Access Compliance Report

Public Rights-of-Way

Intersection ID: 13408	Main Street: COMMONWEALTH_AV	Cross Street: THE_PLAZA	Location: S
ADA ID: 88ED5739A318	Ramp Type: Directional1	Initial Pass/Fail: Fail	Overall Compliance: No
Severity Score: 12.5			
Codes/Mitigation Info/Possible Solution		Field Measurements/Component Compliance

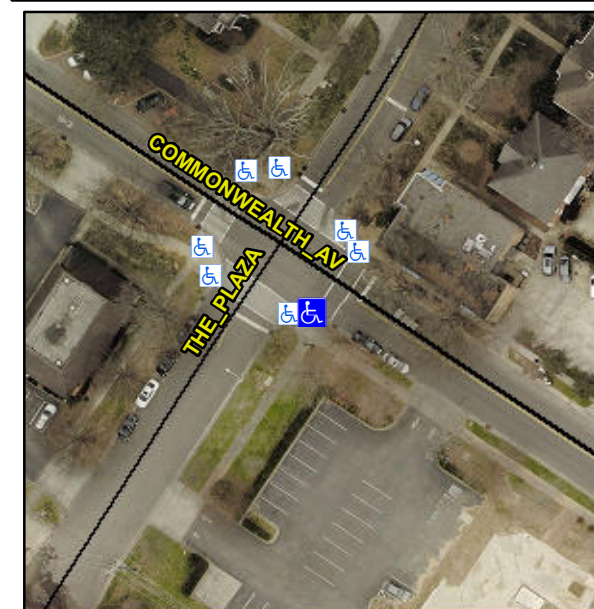
R304.2.2

Remove & Replace Entire Ramp.
